Burlington Development Review Board

BURLINGTON DEVELOPMENT REVIEW BOARD Tuesday January 19, 2016, 5:00 PM Contois Auditorium, City Hall, 149 Church Street, Burlington, VT Minutes

SITE PLAN

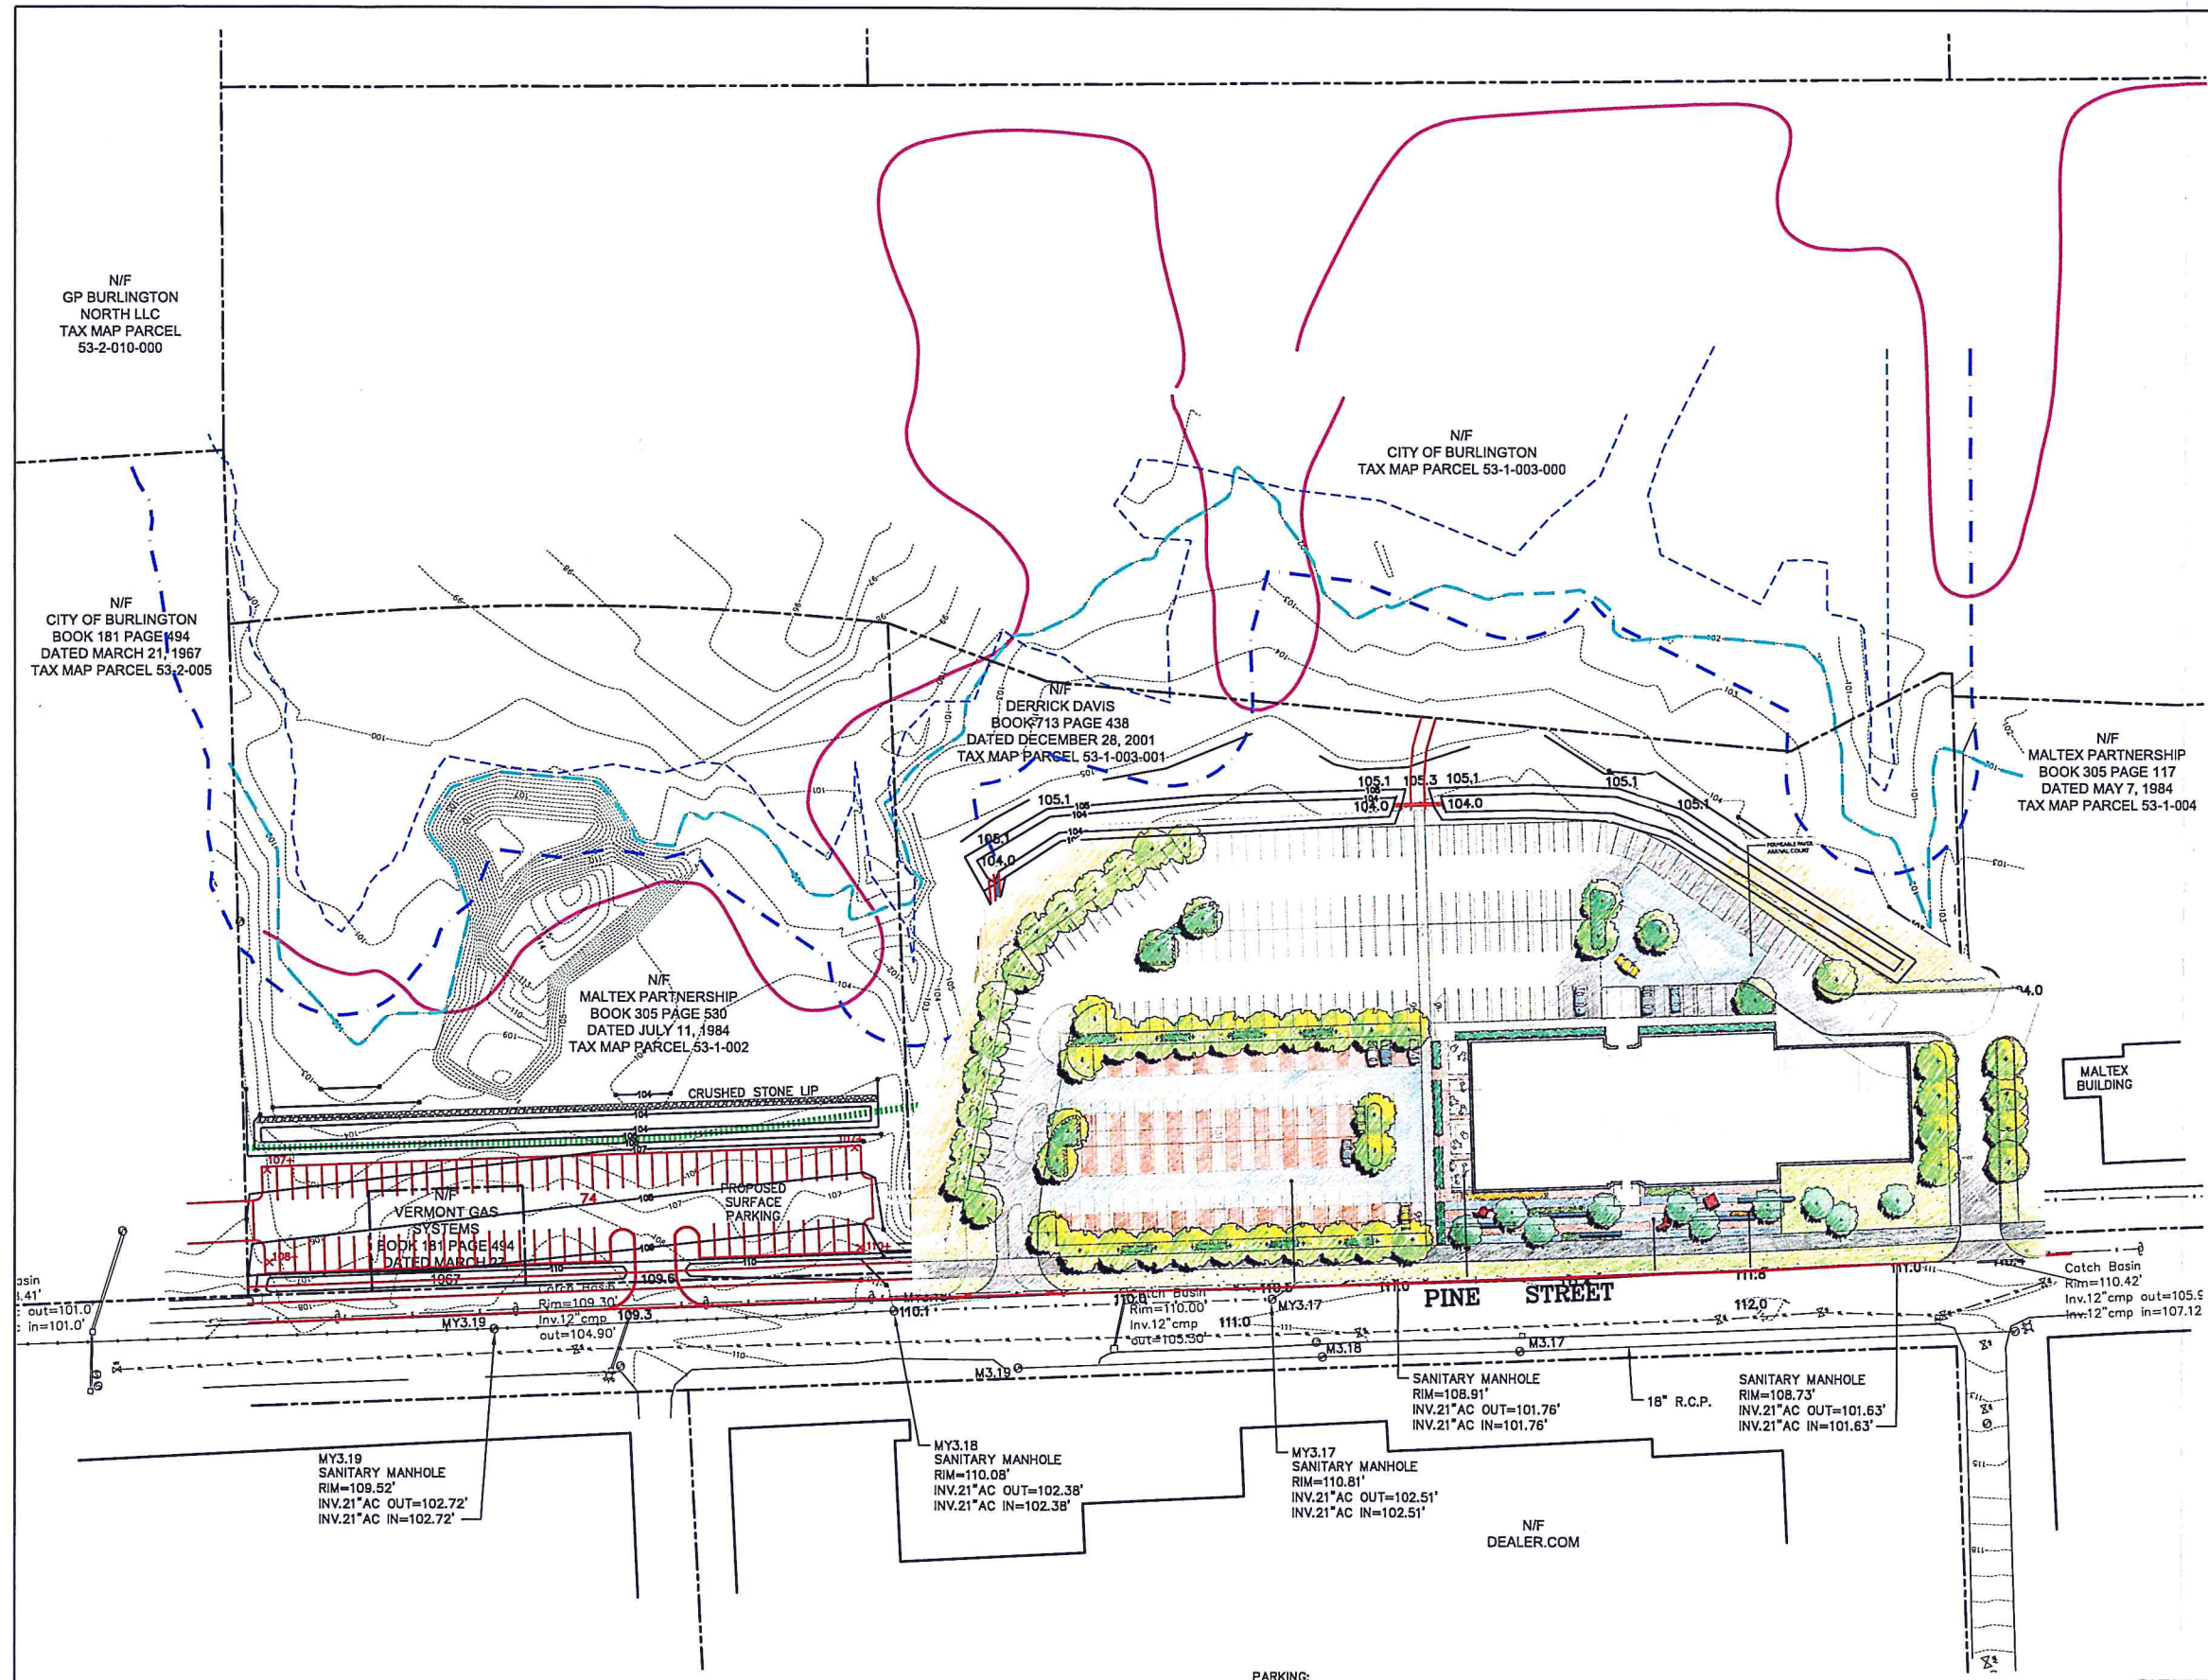
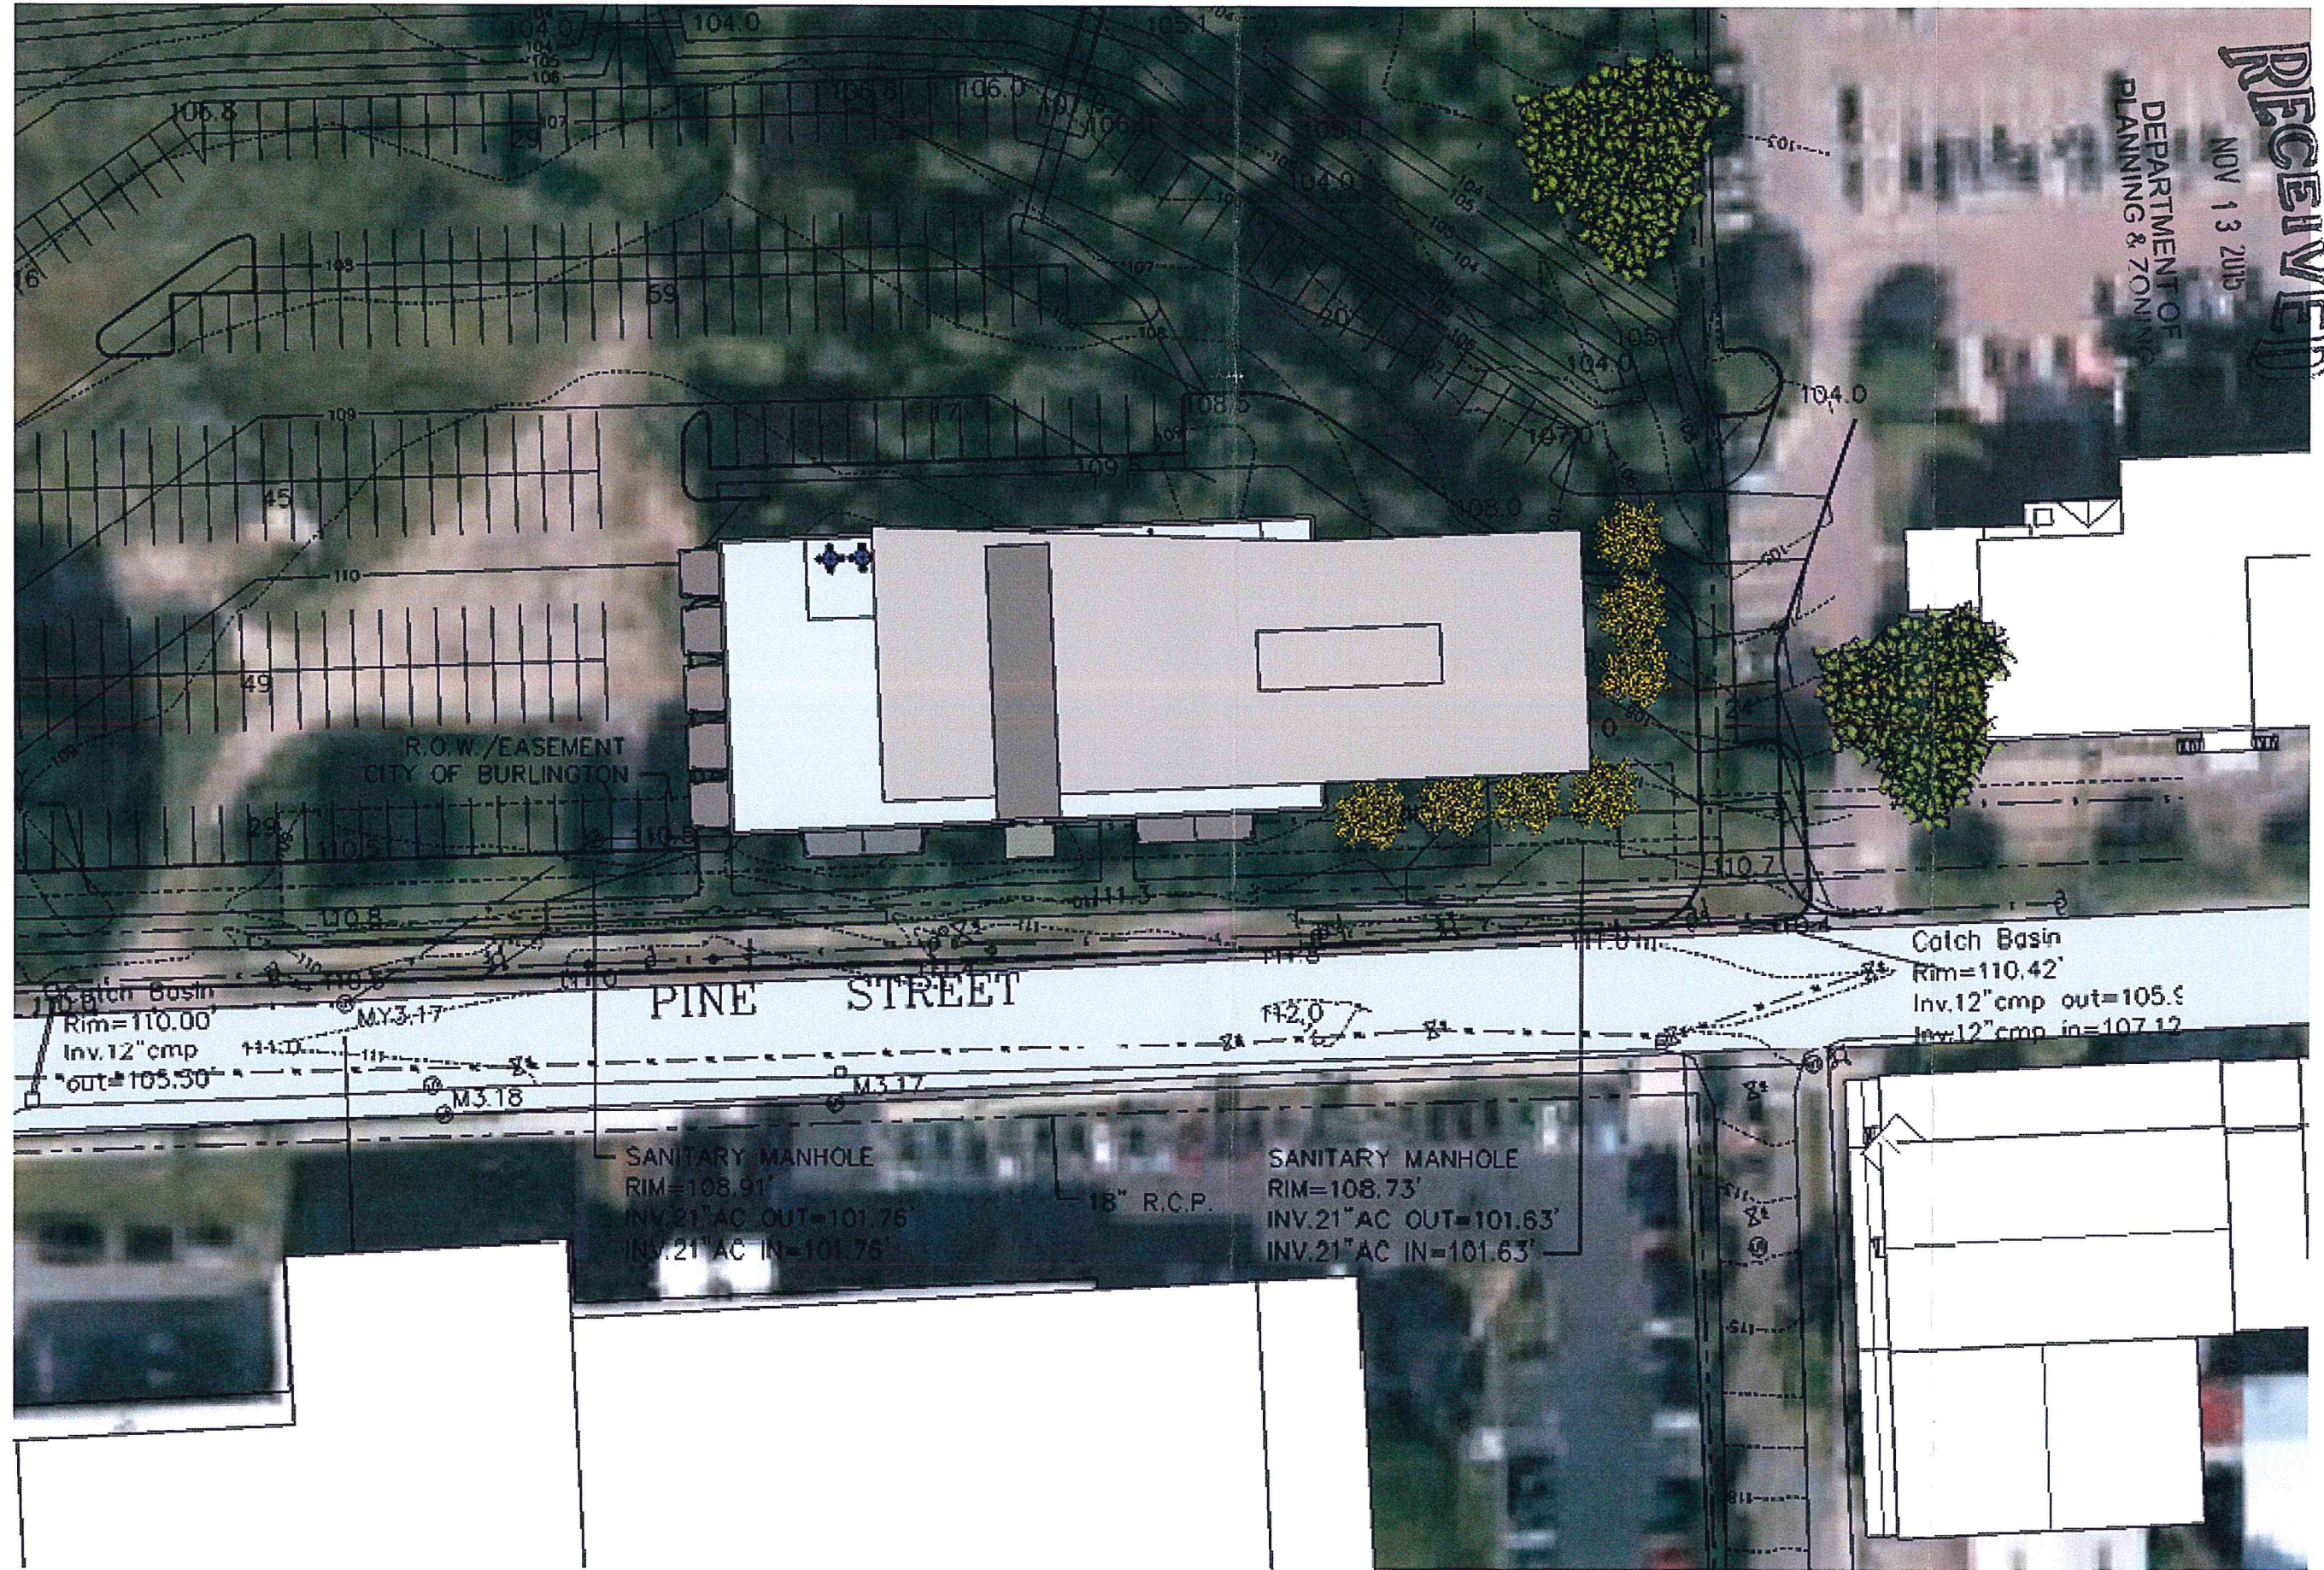
Some basic stormwater information has been provided in the sketch plans. Areas of permeable pavers are proposed along with linear stormwater attenuation structures alongside the surface parking areas. Performance details must be included in the permit application. The applicants are advised to work with the Burlington Stormwater Program to work out proposed stormwater improvements prior to permit application.

The two properties do not contain any important natural features as identified in the Open Space Protection Plan or as outlined in Sec. 4.5.4, *Natural Resource Protection Overlay Districts*. The properties are, however, affected by the buffer zones for several such natural resource overlays. Specifically, wetland and natural area buffer zones originating on properties further west extend onto the subject properties. The site plan depicts a 50' wetland buffer (i.e. the state buffer width); however, the city's wetland buffer is 100' wide and must be depicted for an accurate evaluation of buffer impacts. The site plan does not depict the 100' natural area buffer zone at all and must.

Two access points are proposed for 453 Pine Street, one on either side of the proposed building. The northerly driveway looks as though it could be the existing driveway serving the Maltex building and would provide access to both properties. This driveway lines up with Howard Street on the opposite side of Pine Street. Details are not articulated in the sketch plans, but it appears that both access points could provide entrance and exit from the site. A singular driveway is proposed for access to the surface parking lot at 501 Pine Street. As contemplated by this criterion, a traffic analysis will be required as part of the permit application.

A new multiuse path runs across the length of 453 Pine Street. The sketch plans are unclear as to whether it would extend across 501 Pine Street as well. Such continuation is recommended for ease of pedestrian access. In any event, work within the Pine Street right-of-way will require the approval of the City Council in consultation with the Department of Public Works.

In light of the reduced-size sketch plans, the dimensional adequacy of the proposed parking spaces and associated circulation cannot be assessed. The permit application will require full size true-to-scale drawings to enable such assessment.

All of the proposed surface parking will require the installation of new shade trees. No parking lot shading analysis is included in the sketch plans. This criterion establishes a target of 30% shading of the parking areas with new shade trees. At least 1 shade tree for every 5 parking spaces is required. Minimum caliper size at the time of planting is 2.5" – 3.5" and a mature canopy diameter of 35' is expected. Such details will be required with the permit application.

Some general landscaping information has been provided in the sketch plans. It appears that new trees will line much of the new surface parking at 453 Pine Street. New trees are also proposed within the front yard. It appears that new gardens will accent the building foundation as well. No landscaping is depicted for 501 Pine Street. Landscaping consistent with that at 453 Pine Street should accompany construction at 501 Pine Street. A detailed landscaping plan will be required as part of the permit application.
